Re: License Renewal SNM-719

Docket No. 07000781
Control No. 137575

SUBJECT: PA DEPARTMENT OF ENVIRONMENTAL PROTECTION, REQUEST FOR
ADDITIONAL INFORMATION CONCERNING APPLICATION FOR RENEWAL
OF LICENSE, CONTROL NO. 137575

RADIATION SURVEY AREAS

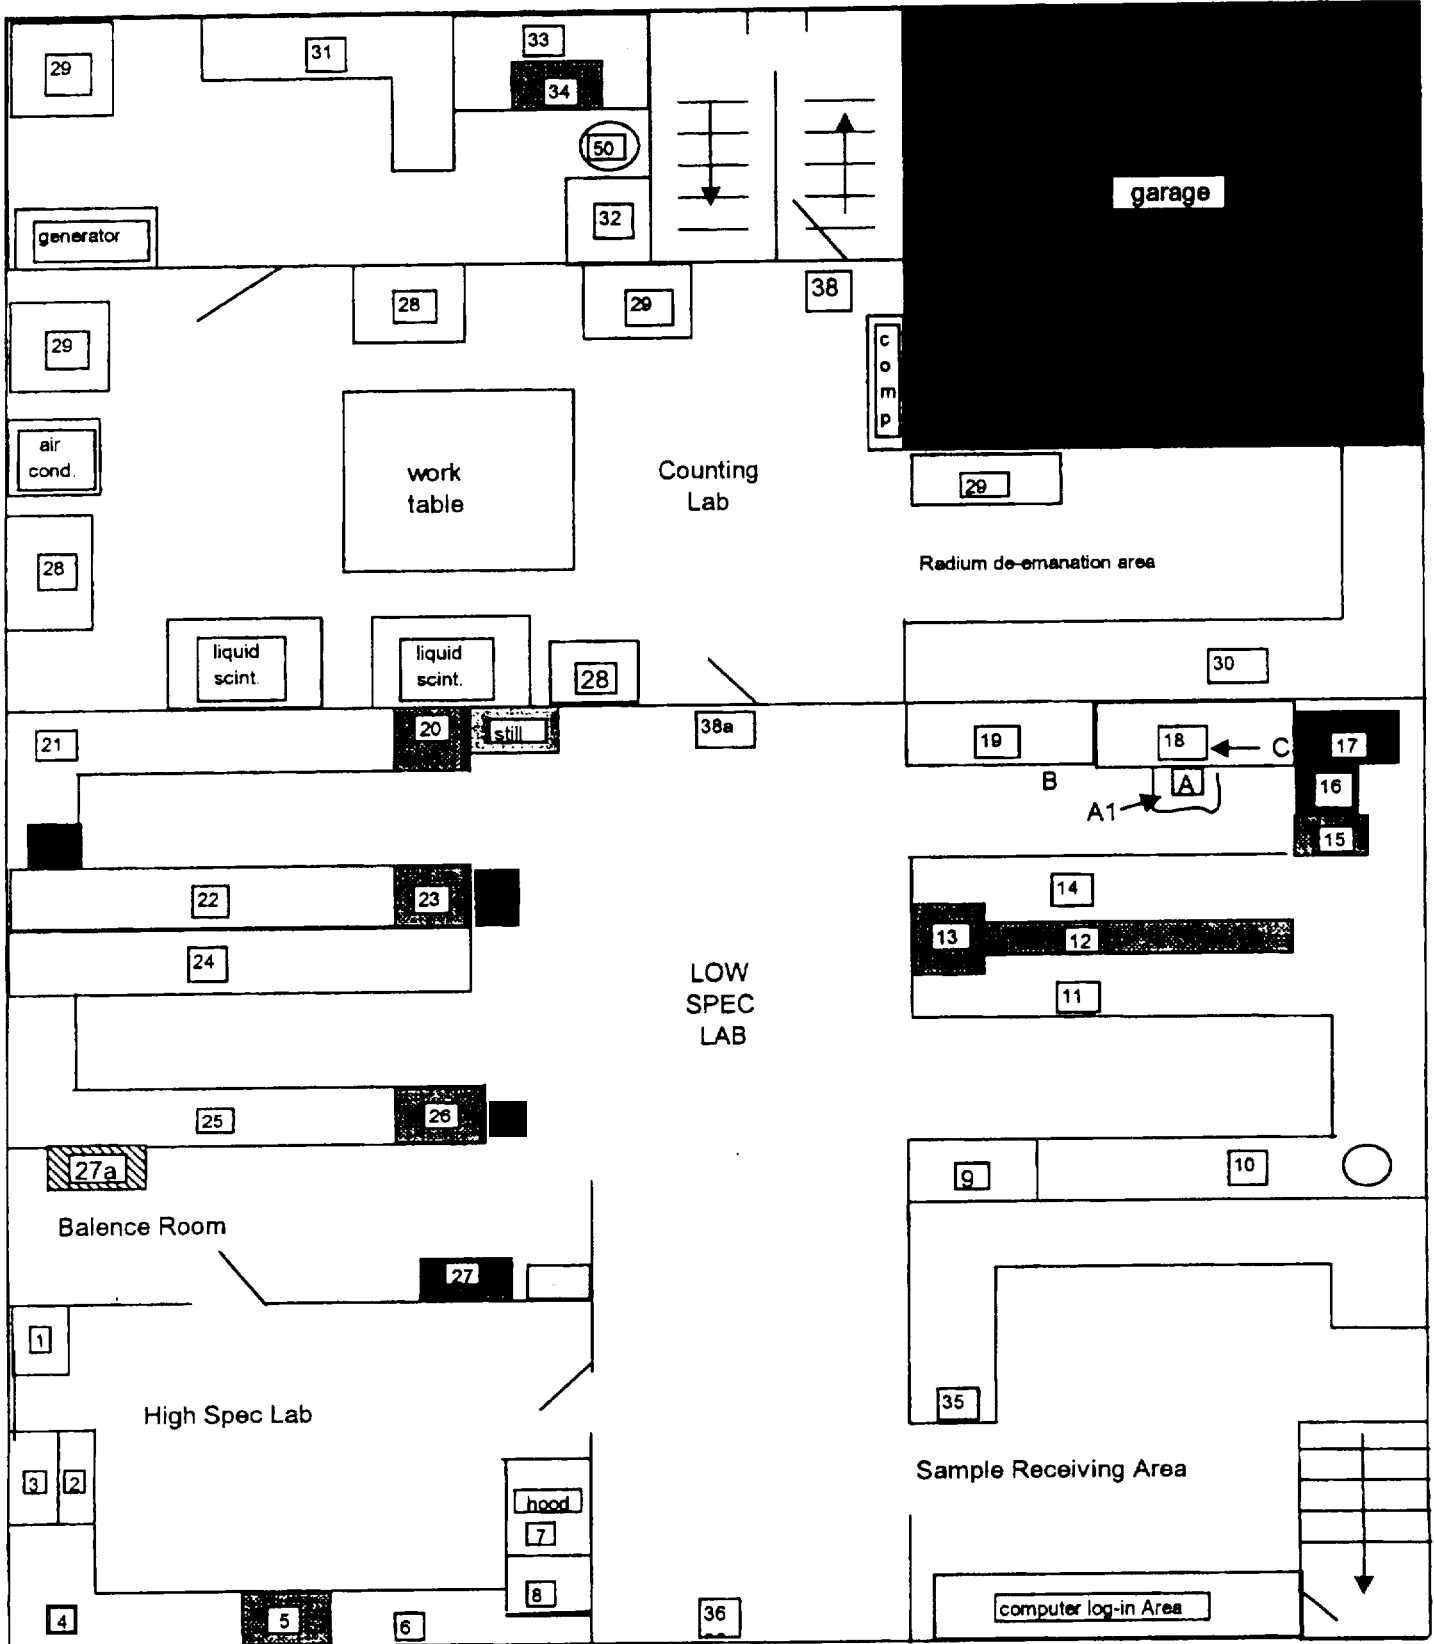
1. In order to remove the facility located at Evangelical Press Building, 3rd and Reilly Streets from your license, you must submit the results of your Final Status Survey Report for review. Guidance for the Final Status Survey Report may be found in NUREG-1757, Volume 2, Section 4.5. 138353

[Item 1. -Attached are results of the final survey and maps with location/work key of the Evangelical Press Building.] 138353

- See attached sheet "Radiation Survey Areas"
